**Ivas Environmental
Environmental Sciences
Wetlands and Planning Services**

**City of Boston Conservation Commission
Boston City Hall
1 City Hall Square
Boston MA 02201**

RE: MA DEP File #: NE - 006-1816, 155 Porter Street, East Boston

This letter covers the attached package of information provided to the City of Boston Conservation Commission. It is written as a response to Mr. Moreno's comments of 03 Nov 21 regarding the proposed project at 155 Porter Street.

3 BUILDING SECTION
A-301 3/32" = 1'-0"

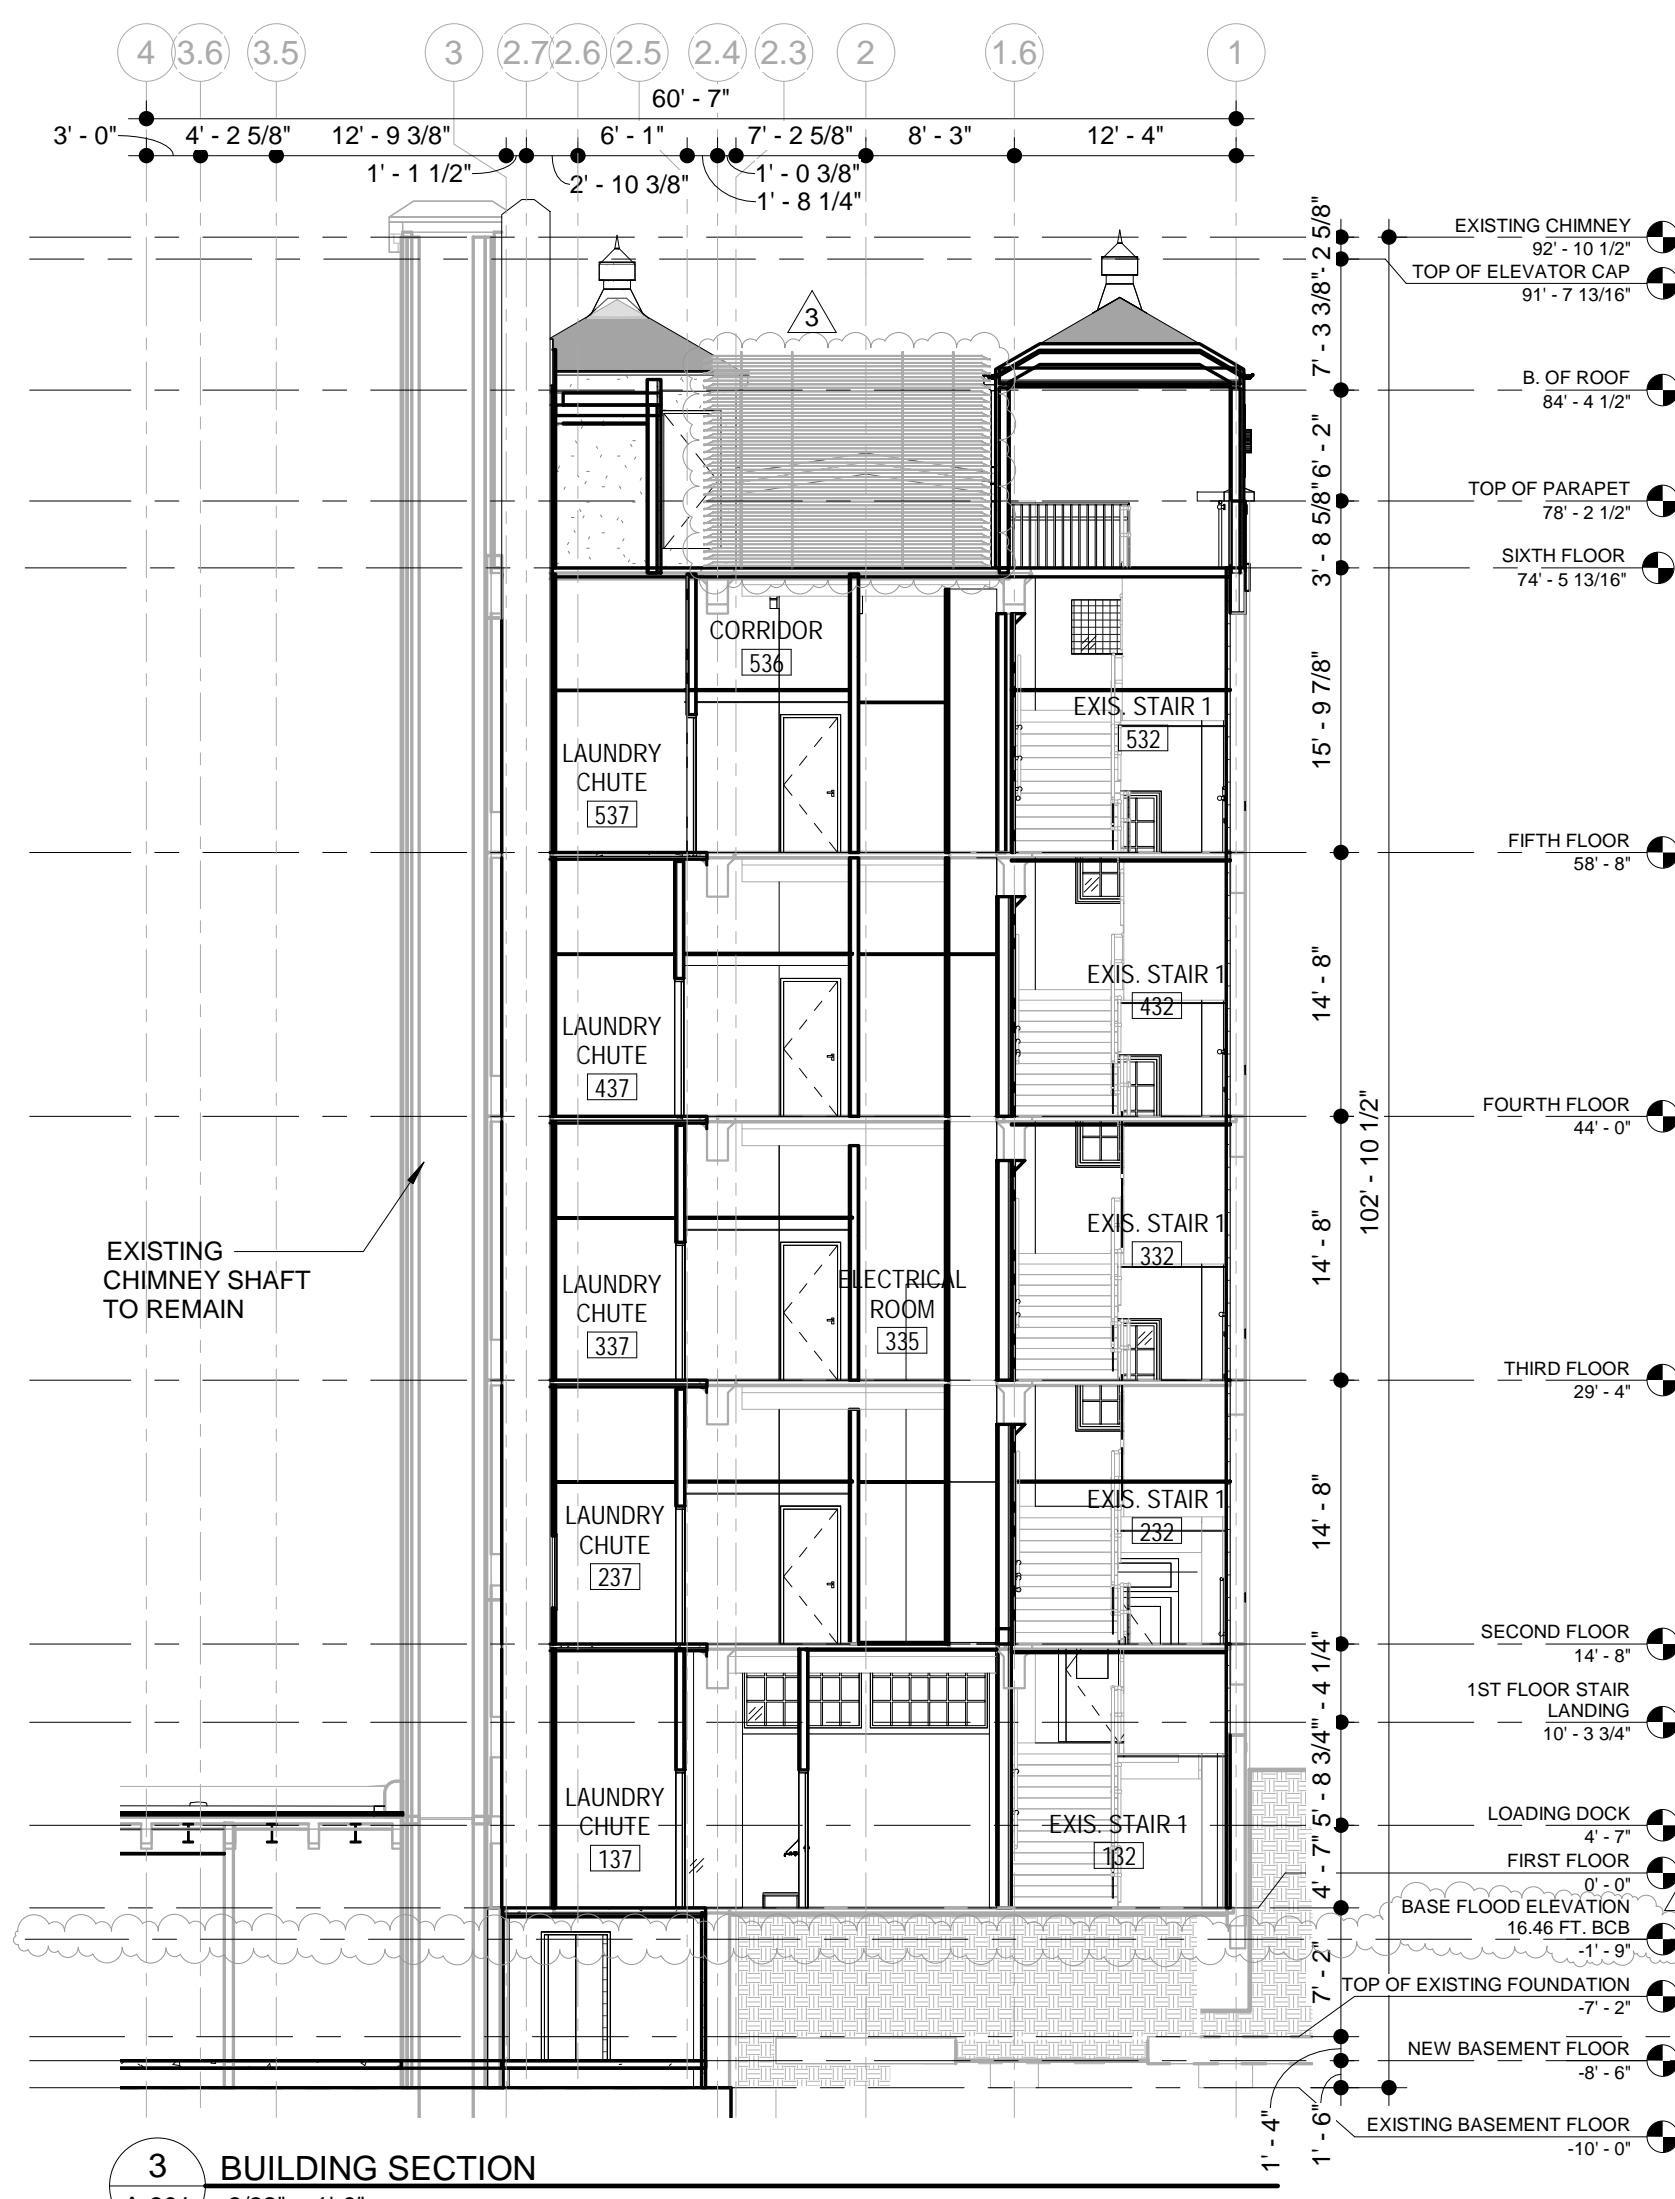
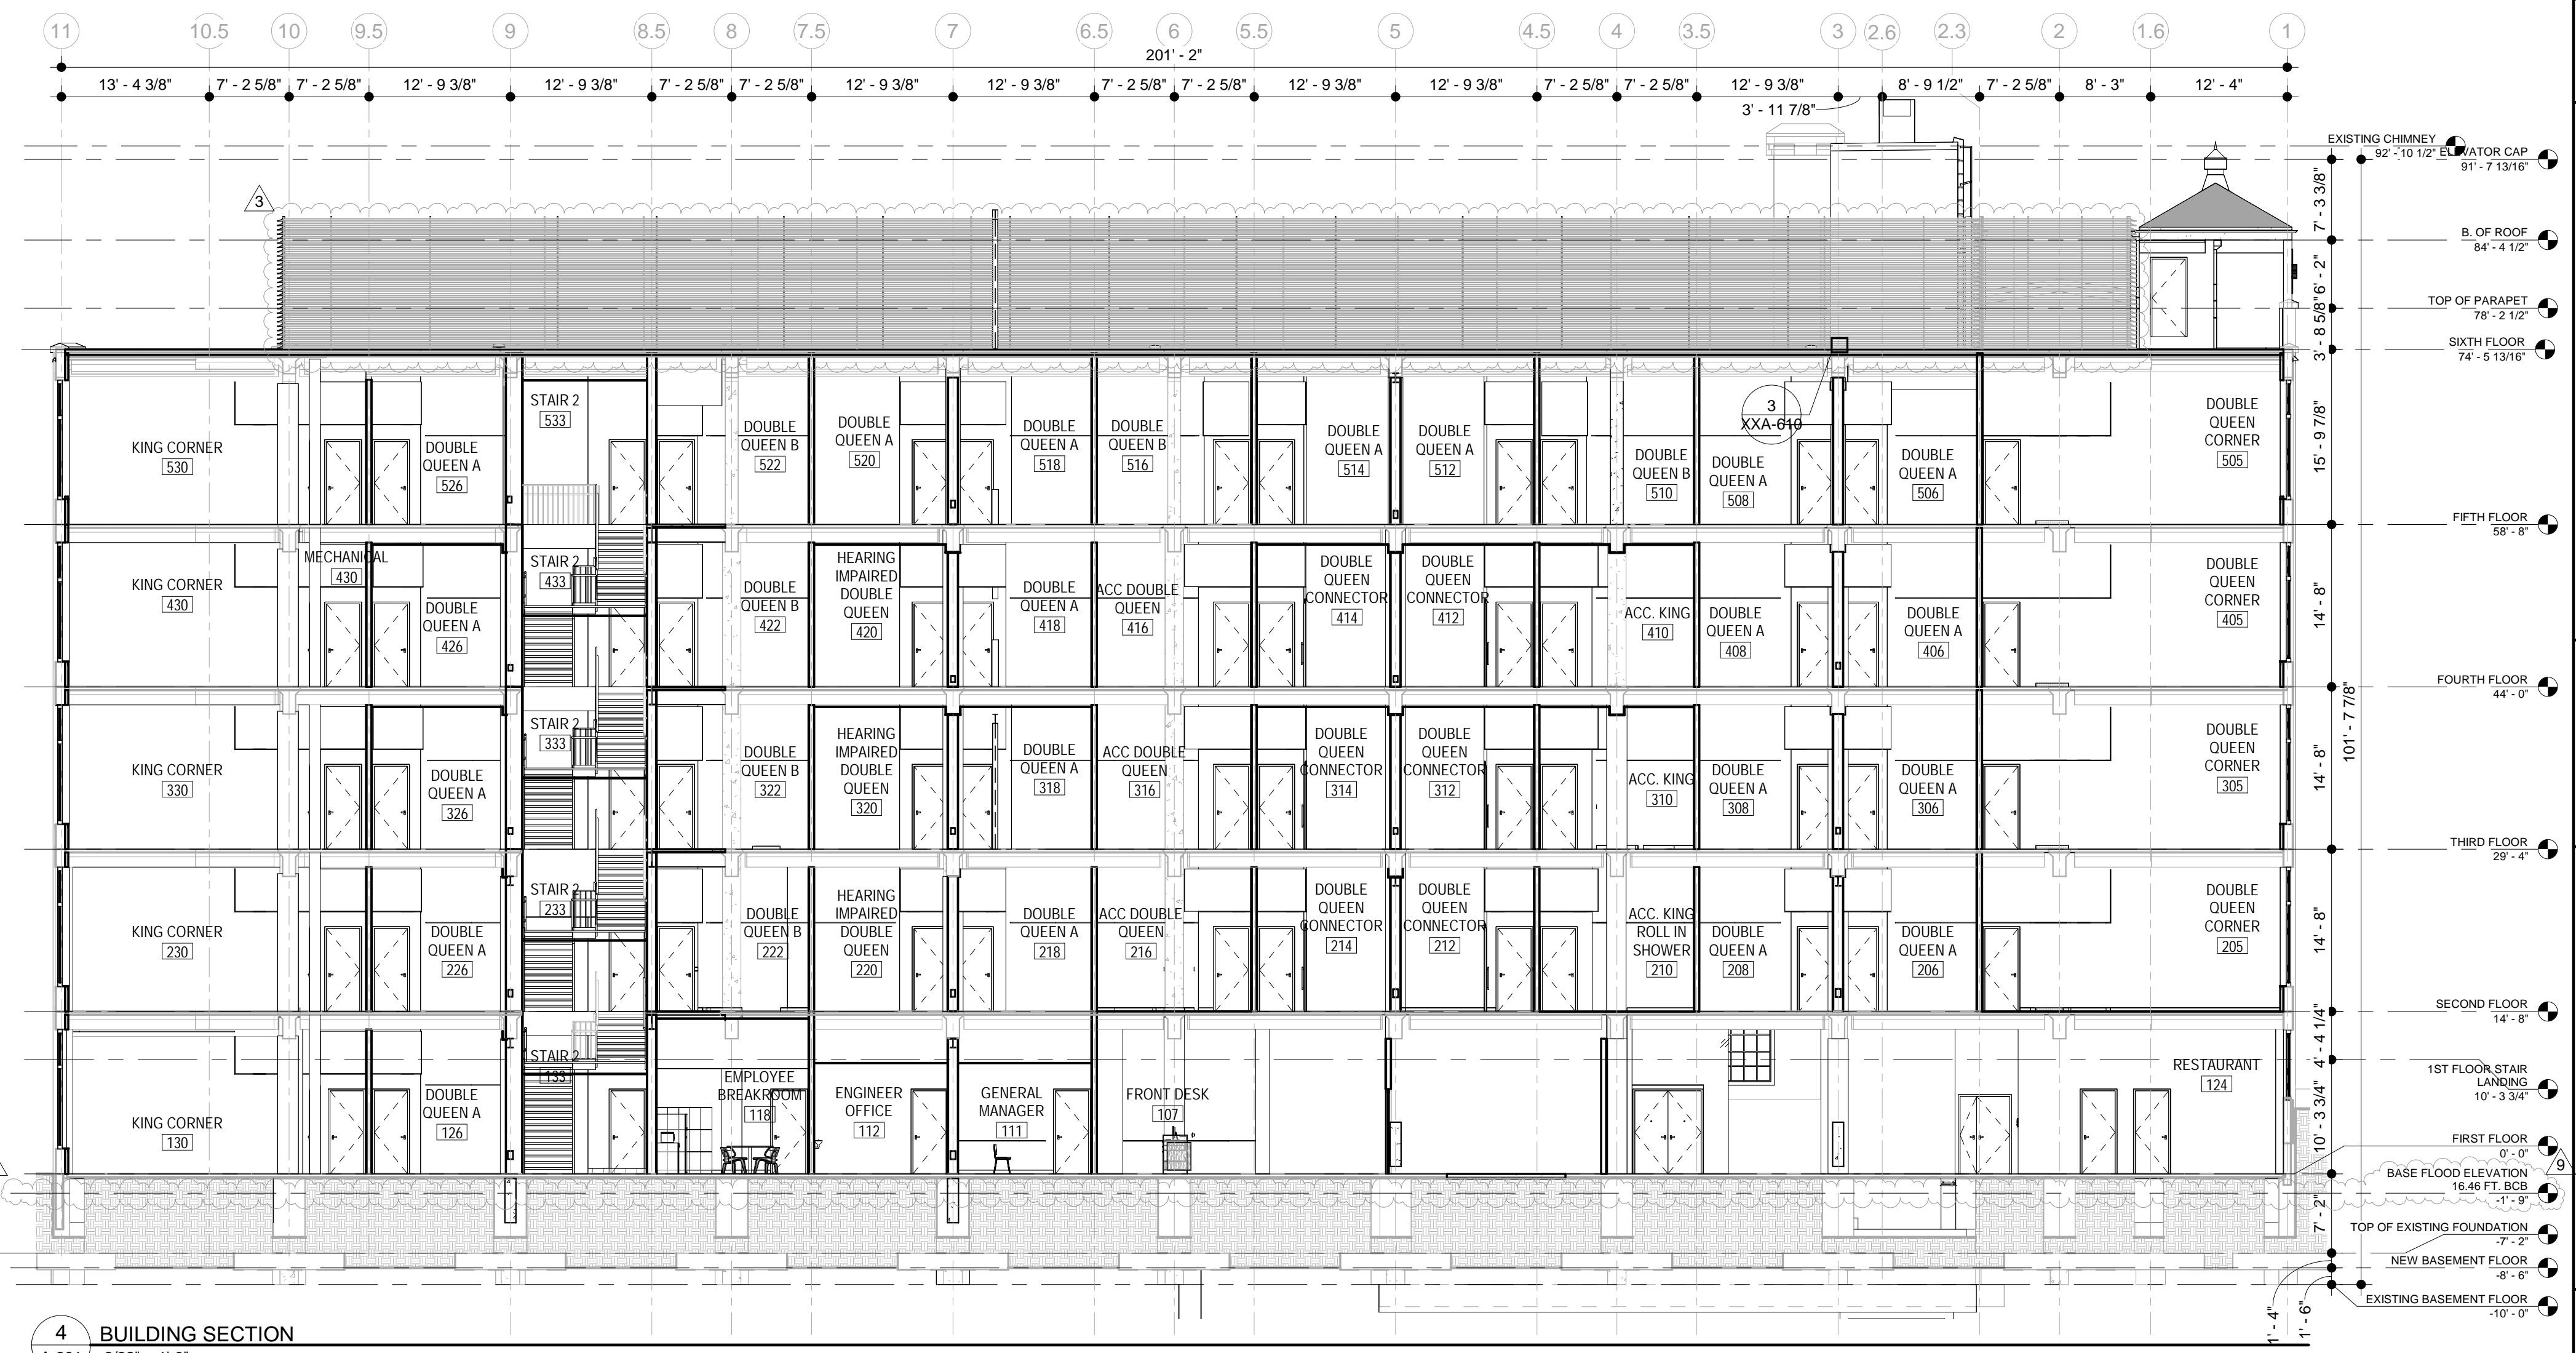
8. Please also include the base flood elevation line on the building section plans.

The base flood elevation has been provided on the building section plans attached.
